**DATE:** May 2, 2017

**TITLE:** **LinkedIn Campus Redevelopment – 700 and  
800 East Middlefield Road and 1100 West  
Maude Avenue**

For City Council to provide input on a proposed office development at 700 and 800 East Middlefield Road, and 1100 West Maude Avenue.

**Proposed Parking Garage Setback**

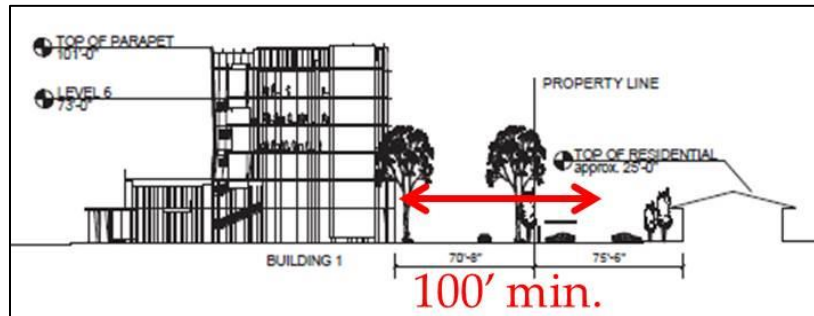
The current office buildings along the eastern portion of the project site are approximately 65' from the shared property line with residential buildings. While one of the office buildings will remain in this location (EP02), the new parking structures are proposed to be set back 57' (Parking 1) and 62' (Parking 2) from the property line and the new office building (Building 1) is proposed to be 80' from the property line. Thus, the new building and parking structures along the eastern project edge will have similar setbacks, or greater, than the current buildings.

More specifically, the parking structures are close to a 1':1' height-to-setback ratio (or 45 degree height setback, as required in the El Camino Real Precise Plan) with 1' in height increase for every 1' set back from the property line. The residential buildings in Sunnyvale have a range of setbacks from the property line of approximately 10' (for a portion of units along the northeast edge near Parking 2) to 75'. Staff believes a minimum parking structure setback of 1':1' height-to-setback ratio may be appropriate for the project site as it permits adequate space for landscape and structure screening, with photovoltaic panels given a height exception as they are a sustainable feature of the project. If Council supports this setback for parking structures, minor modifications to the site plan will be required.

By 7-0 straw vote, Commissioners felt the building and parking structure setbacks seem reasonable for the project, but directed the applicant (and staff) to consult residential neighbors as part of the project outreach process.

*CITY COUNCIL QUESTION 3B: Does Council support a 1':1' height-to-setback ratio for parking structures along a shared residential property line and a minimum 100' building-to-building setback between office and residential buildings for the project?*

**Proposed Building Setback**

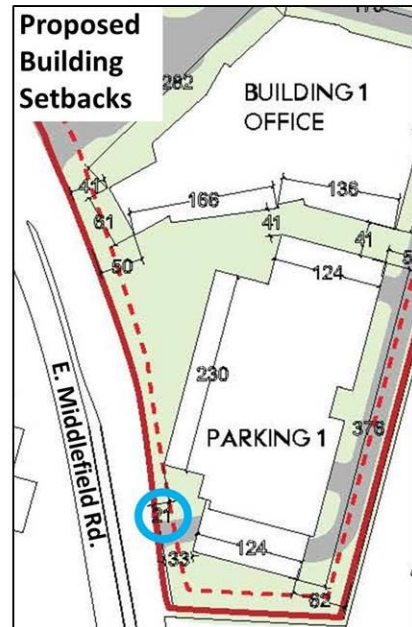
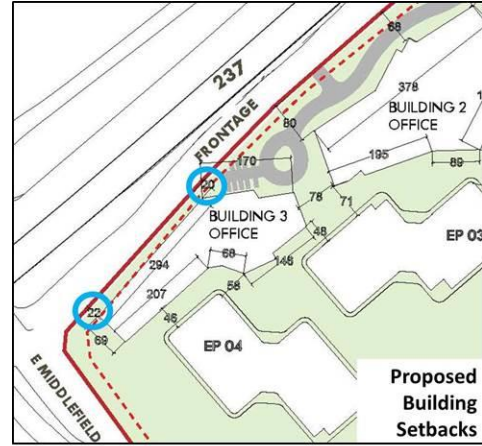
Additionally, the nearest proposed office building (Building 1) to the eastern property line is located approximately 90' from the face of the nearest residential building in Sunnyvale. The City of Sunnyvale zoning requires a 100' setback between industrial buildings (which includes office uses) and residential property lines. The intent of the setback is to provide adequate separation between buildings and uses. Thus, staff is suggesting the 100' setback be carried out between building faces for this project, instead of property lines, due to the unique shape and dimensions of the site. If supported by Council, modifications to the site plan and/or building will be required; however, this will allow the project to be consistent with the intent of the City of Sunnyvale's setback requirement.

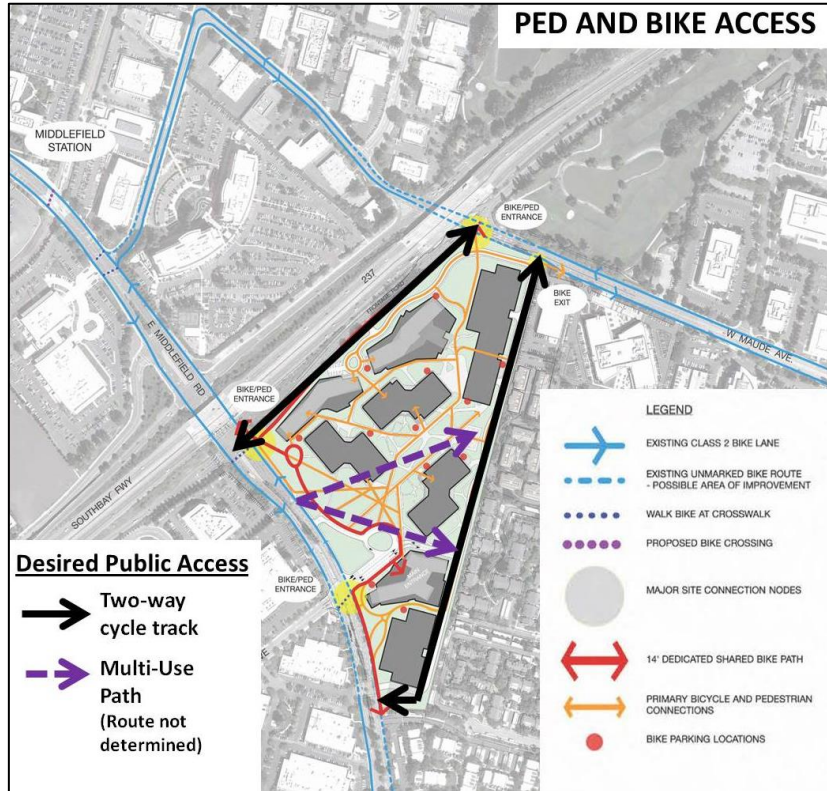
The five existing office buildings have setbacks from adjacent public streets that vary from approximately 150' to 200' to Maude Avenue and Middlefield Road, respectively. While staff supports locating buildings closer to the street to improve street presence, staff is concerned with the proposed proximity of Building 3 (at 20') to the SR-237 Frontage Road and Parking 1 (at 21') to Middlefield Road (see graphics on following page and Sheet A36 of Attachment 4).

As part of the project, City staff will request new separated sidewalks and bike improvements along all three street frontages, which may require placing a portion of these improvements on the project site. With these improvements, the building and parking structure may be located less than 20' from the back of sidewalk along both street frontages. Staff would like the applicant to study alternative site designs that pull back the building and parking structures from the street, which may include reshaping the building/structure footprints or floor plans, and/or pulling Building 3 closer to adjacent buildings (while still meeting building and fire codes). If supported by Council, City staff would work with the applicant to review alternative designs through the development review process, in coordination with the City's Development Review Committee (DRC).

Commissioners unanimously supported having the applicant study design alternatives to allow for greater setback relief. However, Commissioners noted that the modifications should not result in reducing the amount of open area on-site.

*CITY COUNCIL QUESTION 4: Does Council agree with EPC direction for the applicant to study alternative designs for Building 3 and Parking 1 to increase setbacks from the public streets?*

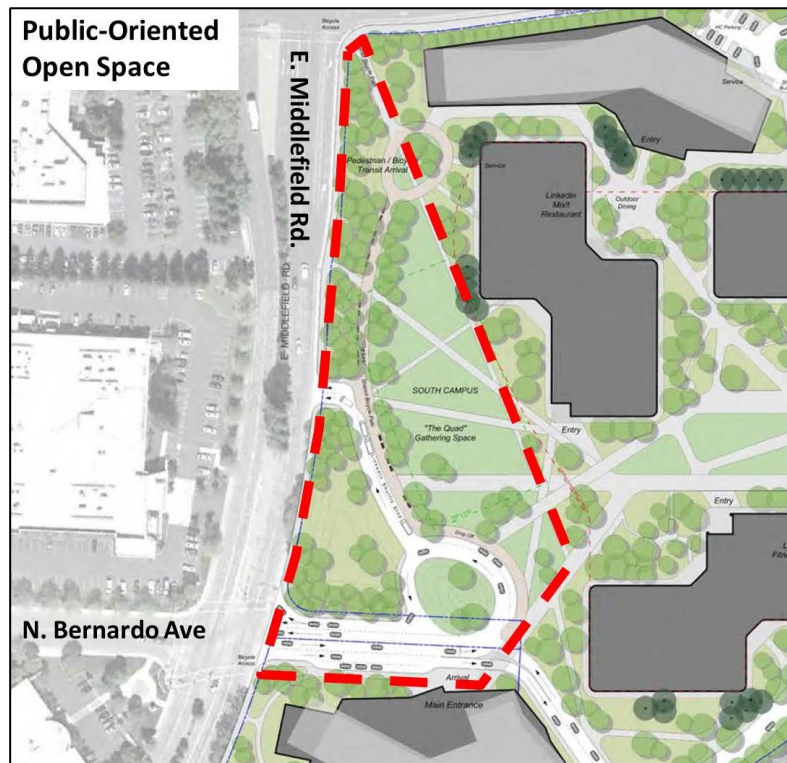
For this project, City staff has identified key pedestrian and bicycle improvements on the project site or frontage, which would improve: (1) access to the site from the VTA light rail; (2) public circulation around the perimeter of the site; and (3) improve connections into Sunnyvale. These improvements include (see graphic on following page):

- *Cycle Tracks (shown in black)* – Provide buffered/separated two-way cycle tracks connecting Middlefield Road and Maude Avenue along the project frontage at the SR-237 Frontage Road with a separated sidewalk, and along the east side of the new perimeter driveway aisle;

- *On-Street Bike Lanes (shown in blue)* – Upgrade on-street bike lanes along the project frontage on

Middlefield Road to a buffered on-street bike lane per the City’s 2015 Bike Transportation Plan Update, with a new separated sidewalk; and include new on-street bike lanes and separated sidewalks along Maude Avenue consistent with the City of Sunnyvale’s bike improvements; and

- *On-Site Multi-Use Path (shown in purple)* – Provide two multi-use public paths for pedestrian and bicyclists through the project site allowing connection from Bernardo Avenue (which may connect with a planned undercrossing in Sunnyvale at Evelyn Avenue/Central Expressway), and from the Middlefield Road/VTA Station to Maude Avenue in Sunnyvale. The exact locations of the paths are not identified at this time.

Commissioners unanimously supported these on-site pedestrian and bicycle improvements for the project. One Commissioner noted support for the bicycle

improvements along the eastern edge of the project site, even if it means potential loss of landscaping and/or trees.

*CITY COUNCIL QUESTION 6: Does Council agree with EPC's support of the identified on-site pedestrian and bicycle improvements for the project, or are alternative connections (or improvements) desired?*
